CPED STAFF REPORT
 Prepared for the City Planning Commission

CPC Agenda Item #5
 May 5, 2014
 BZZ-6482

Property Location: 111 22nd Ave. N.
Project Name: Broadway Resource Recovery Proposed Building Replacement
Prepared By: Aaron Hanauer, Senior City Planner, (612) 673-2494
Applicant: Broadway Resource Recovery, LLC (BRR)
Project Contact: Kathleen M. Osborne, Foth Infrastructure and Environment, LLC
Request: To allow for a building replacement and expansion
Required Applications:

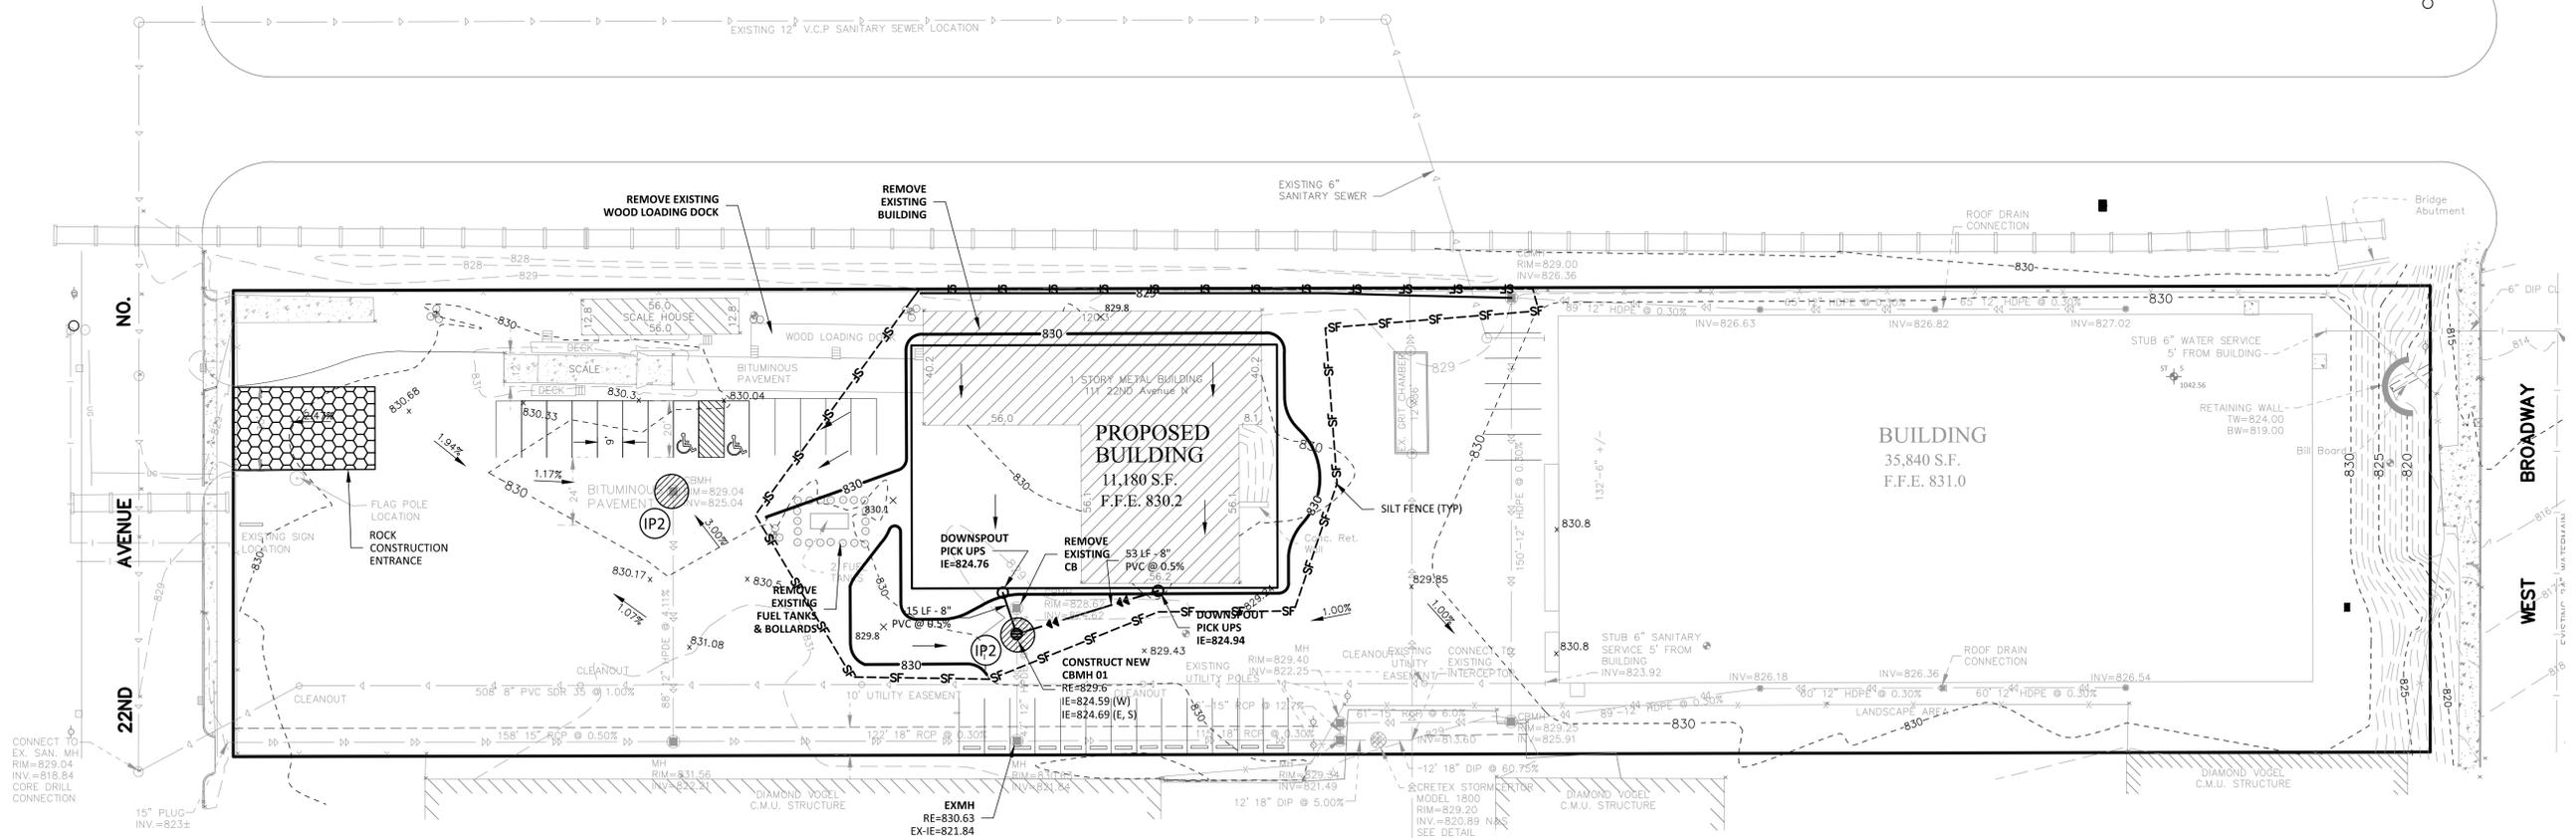
- It is unclear if additional landscaping is proposed on the site, as the Landscape Areas identified on Sheet A1.1 do not seem to match what exists on the site and are not identified on Sheet C1.01. Please clearly identify the area of land disturbance on the plan and provide the total acreage of disturbance.

- Utility: Please identify the extents of the existing utility easement on Sheet C1.01.
- Erosion Control: The proposed silt fence location on Sheet C1.01 should contain the entire disturbed area. It appears there is land disturbing activity occurring to the west of the proposed silt fence.

1 PROPOSED SITE PLAN
 A1.2 SCALE: 1" = 30'-0" ON 24X36
 1" = 60'-0" ON 11X17

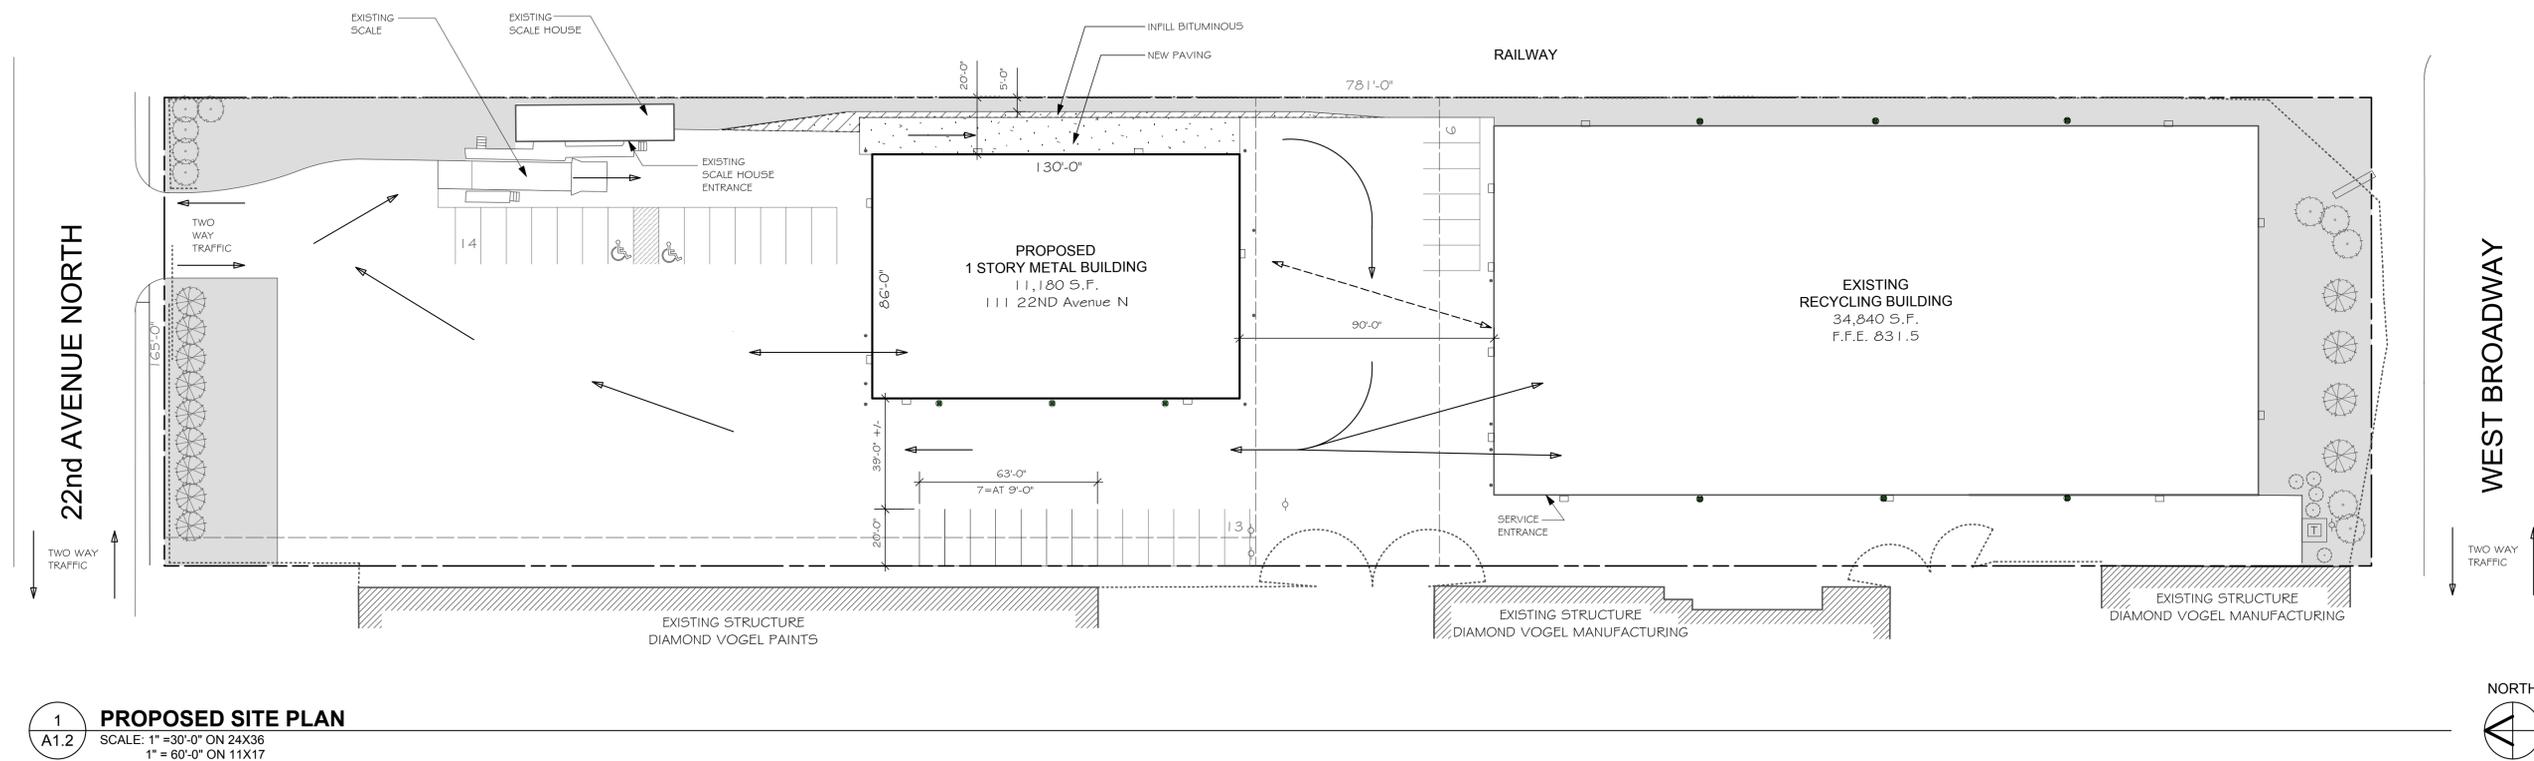
- Revised site plan is required for submission with ADA Sign Post(s) indicated at existing ADA parking spaces, Access Aisle indicating "No Parking" and Accessible Route with min. slope per Minnesota State Accessibility Code Section(s) 402 and 502.
- Two service doors shown on floor plan sheet # A2.1 are required to be ADA compliance doors with required landing of minimum 5'0" x 5'0" landing with min. slope and door hardware/clearance per Minnesota State Accessibility Code Section(s) 403, 404.2.2, 404.2.3, 404.2.6, 404.2.9 and 1105.1.
- Submit copy of SAC Determination Letter. Contact the Met Council for this determination, see http://www.minneapolismn.gov/www/groups/public/@regservices/documents/webcontent/convert_281675.pdf for more information.

2
A3.1
WEST ELEVATION
SCALE: 1/16" = 1'-0" ON 24X36
1/32" = 1'-0" ON 11X17

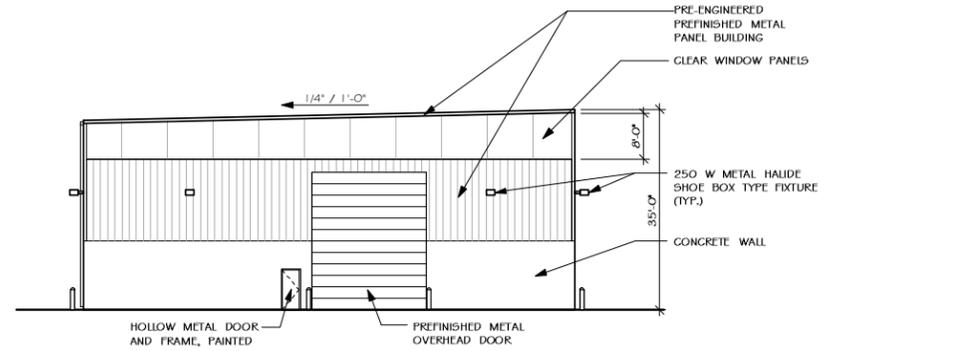
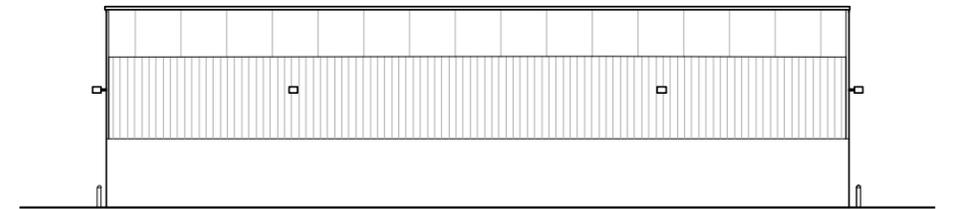
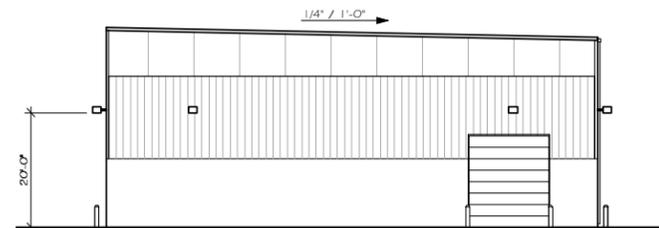
1. Building elevations: I know the drawings are not completed, but I am assuming you are looking to match the building materials and design of the existing building, correct? This will be encouraged/recommended to the planning commission. If that is the case, please show that on the elevations.

3. Building design: Building walls shall provide architectural detail and shall contain windows as required in this section in order to create visual interest and to increase the security of adjacent outdoor spaces by maximizing natural surveillance and visibility. You will likely not meet our window percentage, but consider putting windows on the building elevation along 22nd Avenue North, per 530.120.

C. Elevation Sheets: Drawing A2.1 shows the clear window panels with seams between each panel. The panels will be eight feet high on the high side of the building and six foot four inches high on the low side of the building. The panels will be eight feet wide and are meant to look like one continuous band. The proposed building appearance will complement the existing Recycling Building.

Response: The new building elevations submitted on 3-14-14 did show building materials and a design that matches the existing Recycling Building.
2. Building location: We encourage you to look at bringing the new building closer to 22nd Avenue North (similar to the adjacent buildings) while allowing trucks to wait on your property and not on 22nd Avenue North. Per 530.110, the placement of buildings is supposed to reinforce the street wall, maximize natural surveillance and visibility.

Response: The new building will include clear window panels on the top side of the building (as shown on the Elevations) instead of traditional windows. Traditional windows in this building would be problematic due to the equipment used for material sorting.
4. Landscaping along West Broadway: We highly encourage you as part of this conditional use permit to propose a landscaping plan that enhances your elevation along West Broadway Avenue. As stated in the 2007 report, West Broadway Avenue is an important commercial and transportation corridor. A well designed landscaping plan (it may include a designed perennial plan, but don't just rely on that). The combination of perennials and more plantings to fill in the area along West Broadway, would go a long ways of continuing the improvements that have been happening along this corridor.
